NUCLEAR MANAGEMENT COMPANY, LLC NMC RESPONSE TO NRC STAFFS' REQUEST FOR ADDITIONAL INFORMATION REGARDING EVALUATION OF LICENSE AMENDMENT REQUEST 213 TO KEWAUNEE NUCLEAR POWER PLANT, OPERATING LICENSE NO. DPR-43 DOCKET NO. 50-305

Electrical and Instrumentation Control Branch (EEIB) **Questions**

Figure 1 – Partial Elevation View of CST Supply Piping

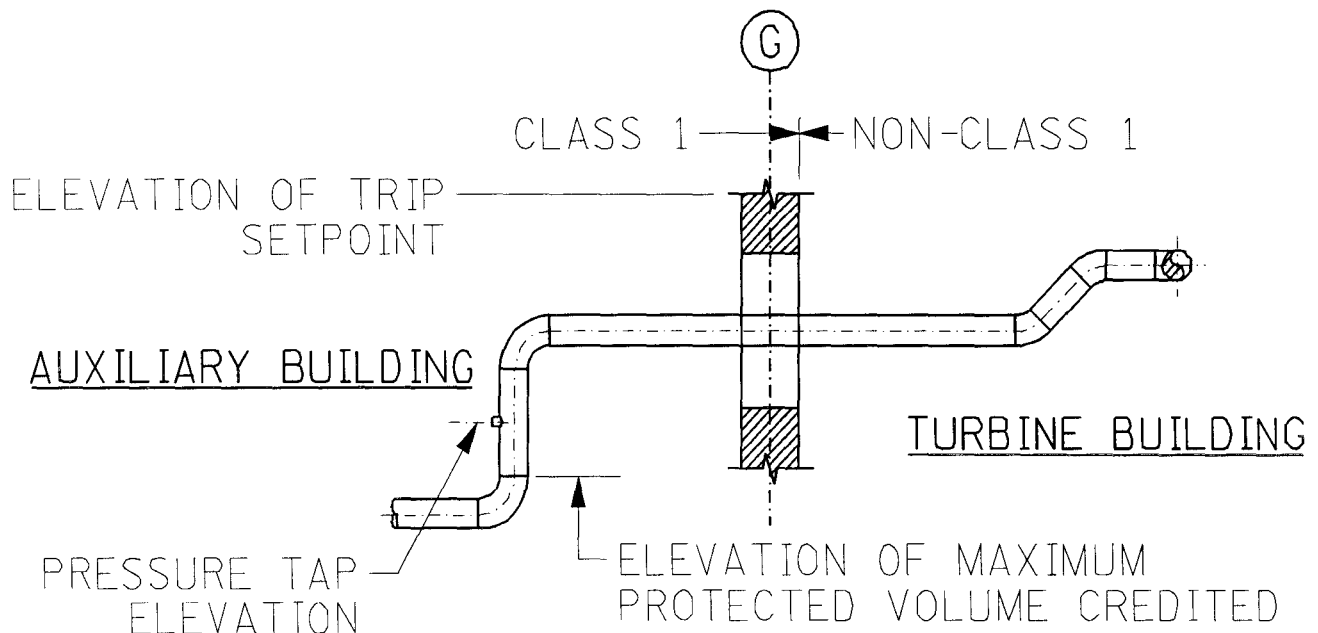
Plant analyses have demonstrated that the suction pressure trip combined with an additional suction water volume protect the AFW pumps by sensing loss of suction, tripping the associated AFW pump, and providing sufficient reserve water volume to allow the AFW pump to coast to a stop, thus preventing AFW pump damage. Is there a check valve or isolation valve between the Class 1 section and the non-Class 1 section of the suction piping to prevent loss of the reserve water volume through the non-Class 1 pipe break?

The following is a simplified elevation view of a portion of the condensate storage tank (CST) supply piping showing the Class I to non-Class I location at the Class I wall between the Auxiliary Building and Turbine Building.

Non-Class I water supply from the CST is provided through the Turbine Building into the Class I piping within the Auxiliary Building. As shown above, the suction trip setpoints are established above the credited protected volume. No check valve or isolation valve is required to prevent a loss of fluid from the protected volume from a non-Class I break due to the difference in elevation. If there was a complete failure of the non-Class I piping, the break location remains at a higher elevation than the protected volume and the protected volume remains unaffected. Additionally, should the failure of the non-Class I piping occur, the suction pressure trip switches would sense the loss of CST supply head pressure and function to protect the pumps as designed. Therefore, there is no functional need for a check valve or isolation valve between the Class I section and the non-Class I section of the suction piping to prevent loss of the protected water volume through the non-Class I pipe break or to ensure the function of the suction pressure switches.

Figure 2 – Illustration of Pump Parameters Used for Discharge Pressure Setting Determination

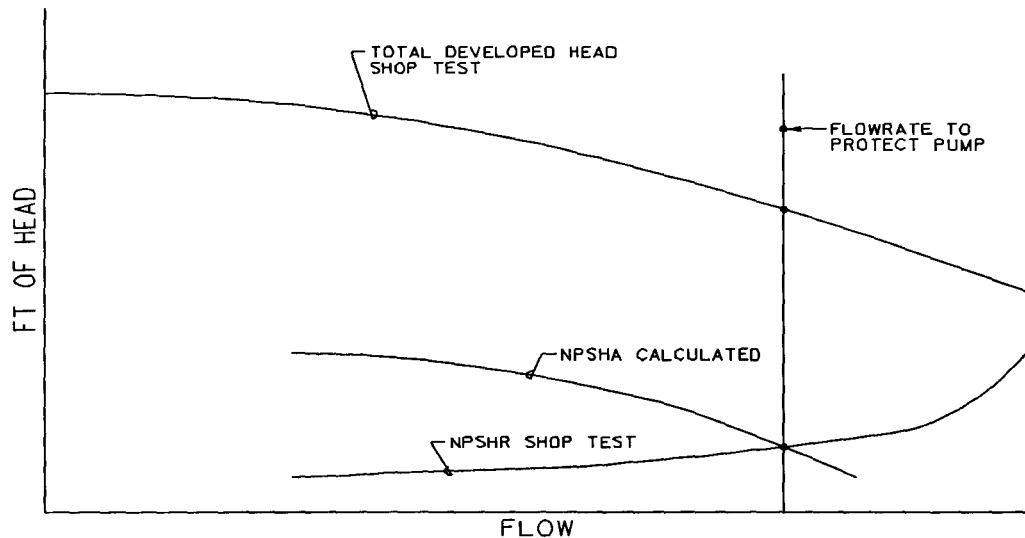
Low AFW pump suction pressure trips were not installed previously to provide the necessary protection for low net positive suction head because of sub-atmospheric conditions at the suctions of the AFW pumps and instead, low AFW pump discharge pressure trips were installed to provide the necessary protection. Please explain why the sub-atmospheric conditions that exist at the AFW pump suctions no longer pose a problem.

The discharge pressure switches will continue to be utilized for pump protection when inadequate NPSH is available. The AFW pumps are suction side flow limited due to the suction line losses, which causes inadequate available NPSH. The discharge pressure switch set points were increased to trip the pumps before they get into a suction limited run out condition. The following illustration provides a graphical representation of the methodology used to select the discharge pressure trip settings.

The method used to determine the flow rate at which the pumps are tripped was selected per calculation at a flow rate where available NPSH (NPSHA) equals required NPSH (NPSHR) for two pump operation, as shown in Figure 2. At this selected flow rate, the pump suction pressure is slightly above atmospheric pressure. Three-pump operation is not a factor because there would have to be multiple equipment failures to operate with more than two pumps operating in run out conditions, which is outside of licensing basis. This method is conservative because the only time multiple pumps may operate for any extended period of time in this flow range is on a faulted line or uncontrolled feeding of a depressurized SG. Due to the physical location of the suction pressure trip switches well upstream of the pumps' suction and tripping the pumps at a lower flow rate, the suction pressure losses affecting the suction pressure switch function are reduced. Therefore, sub-atmospheric conditions that existed at the AFW pumps' suction in the past that could impact the performance of the suction pressure switches no longer pose a problem.
